ASR Feasibility in Bandera County

**Plateau Region Water Planning Group
and
Texas Water Development Board**

Response to TWDB Comments on Draft Final Region-Specific Study Reports

Region J, Region-Specific Contract Study #2 *Water Rights Analysis and ASR Feasibility in Kerr County;* *ASR Feasibility in Bandera County*

Figure 3.1 Annual diversions from the Medina River in the vicinity of the City of Bandera

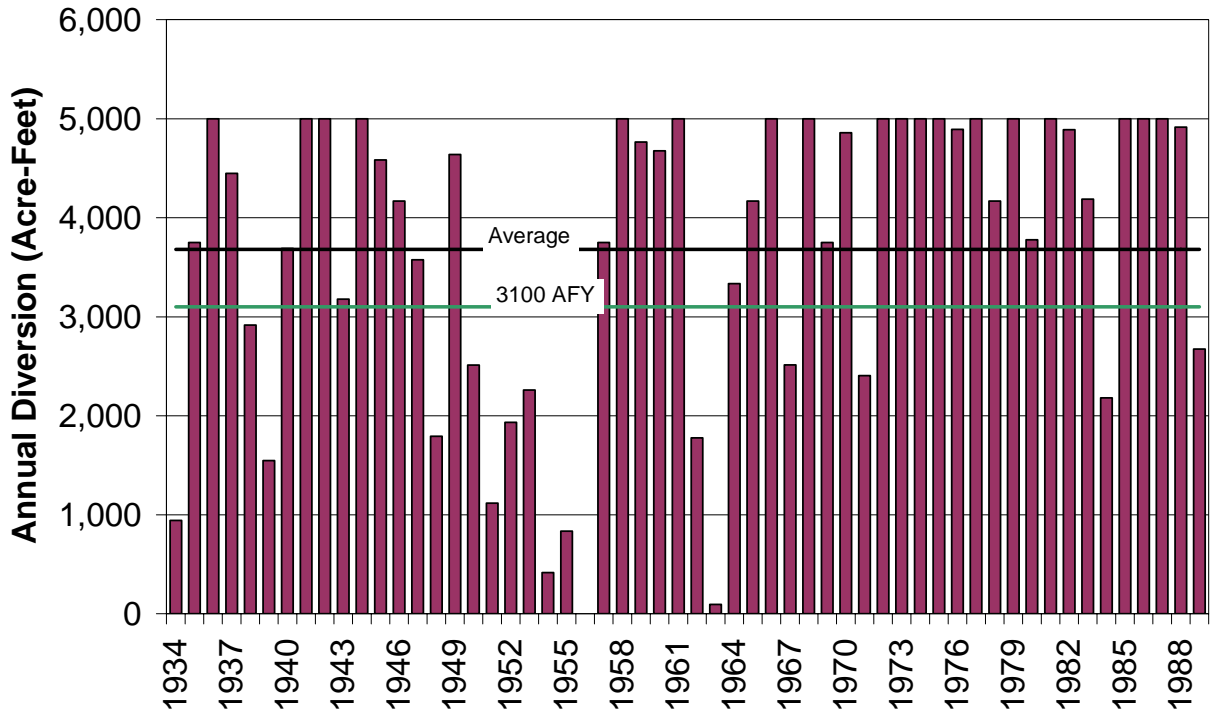
4. Report 2, Page 3-3, Figure3.1: Please add units to the axes of the graph in the final report.

*Response: Units are added to the graph.*

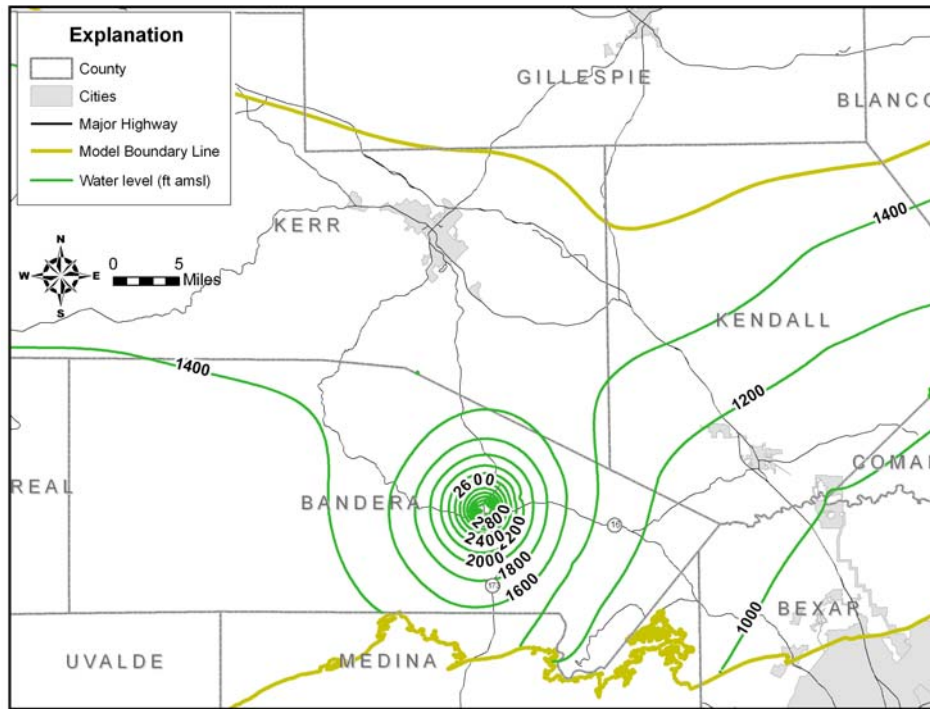
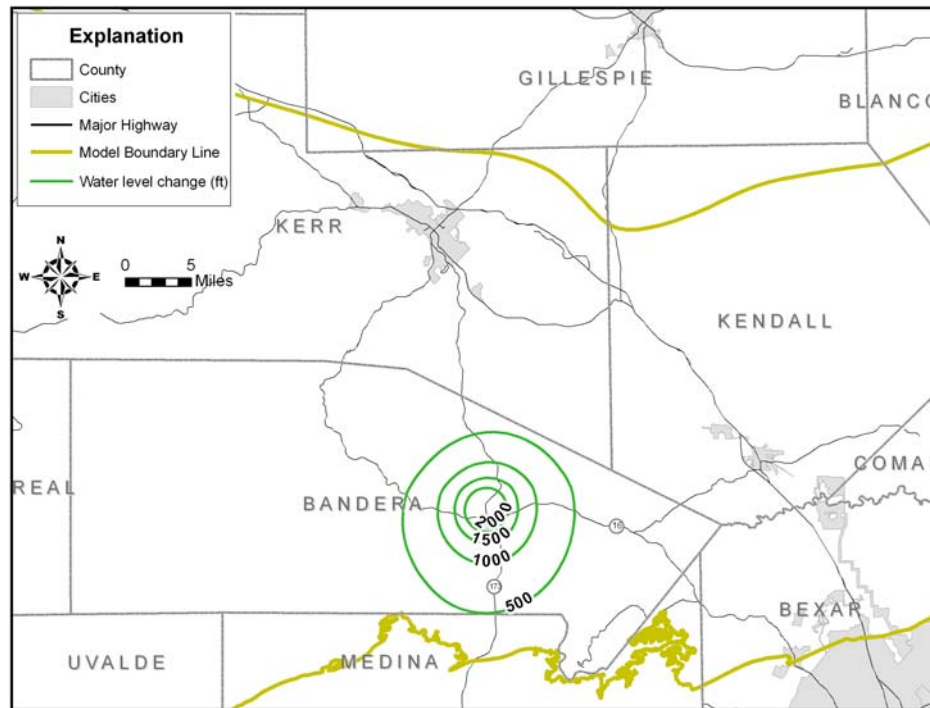
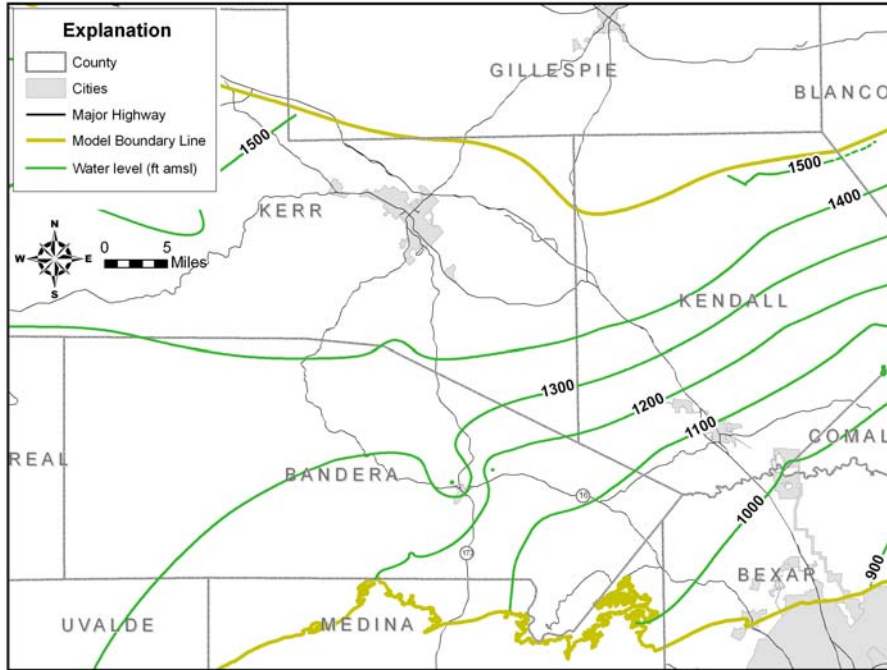
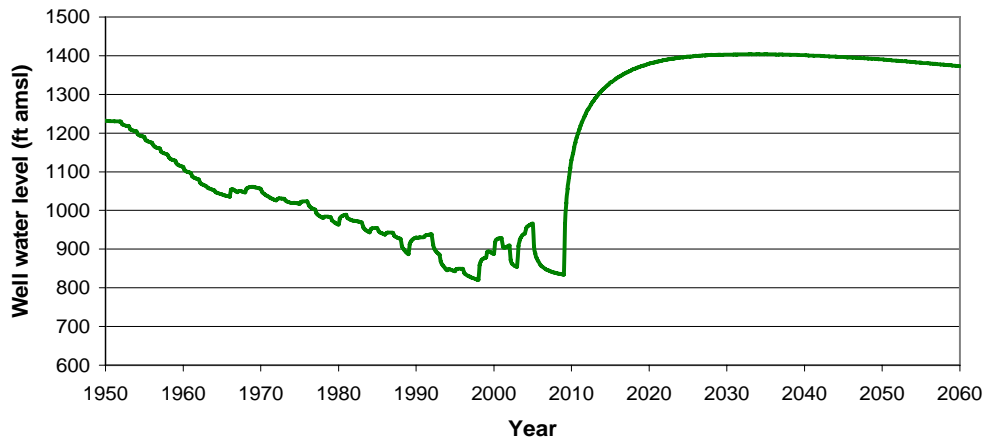
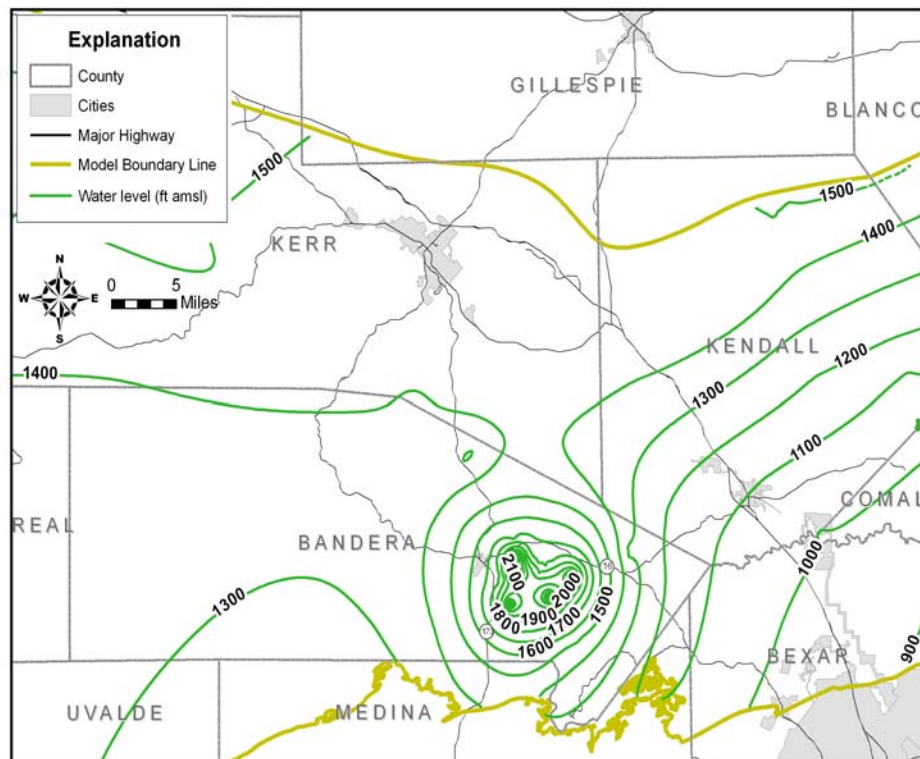
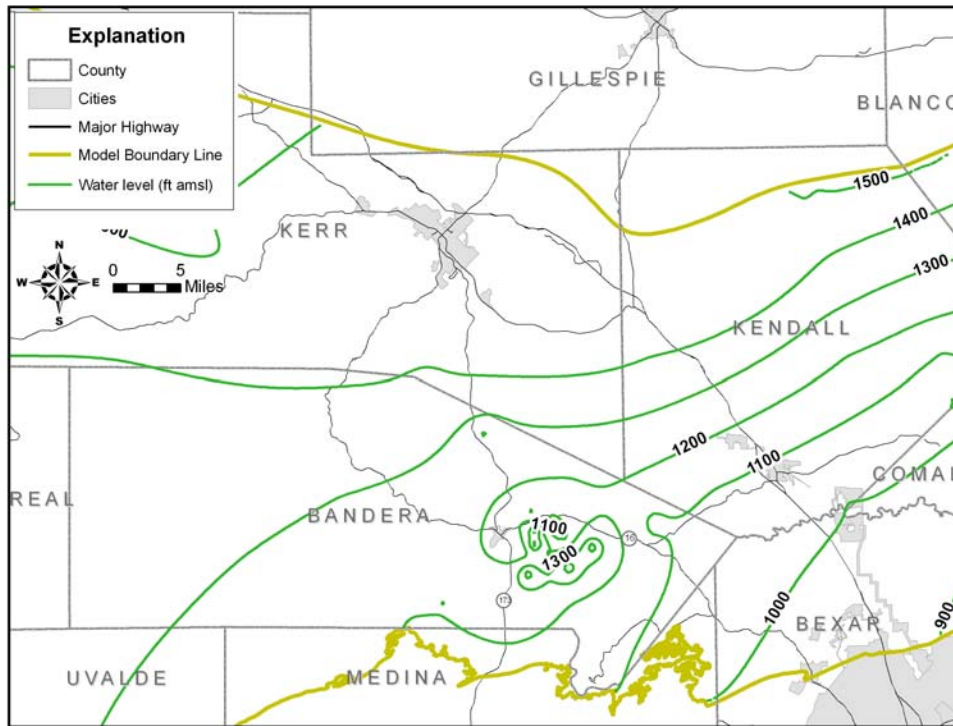
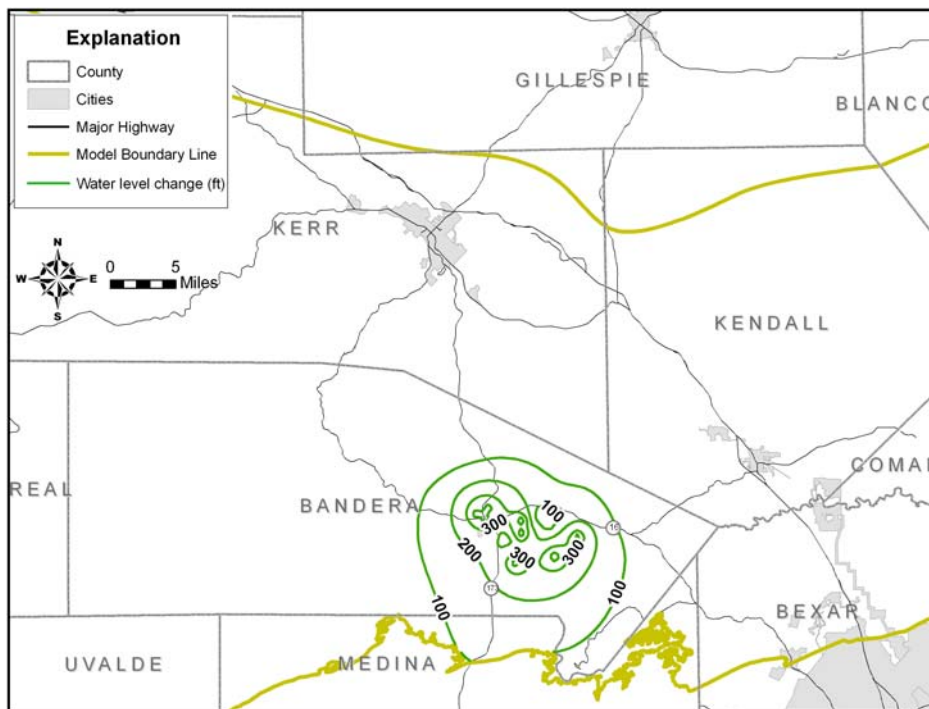
8. Report 2, Section 5 Figures: (a) pages 5-4 to 5-7, Figures 5.1 to 5.7: Please identify the year for which water levels and water level changes are shown in these figures; (b) page 5-6: Please consider including water levels and water level changes for Scenario 2a in the final report.

*Response: Figure titles have been revised to show conditions in 2060. Figure 5.5 now shows the Scenario 2a conditions.*
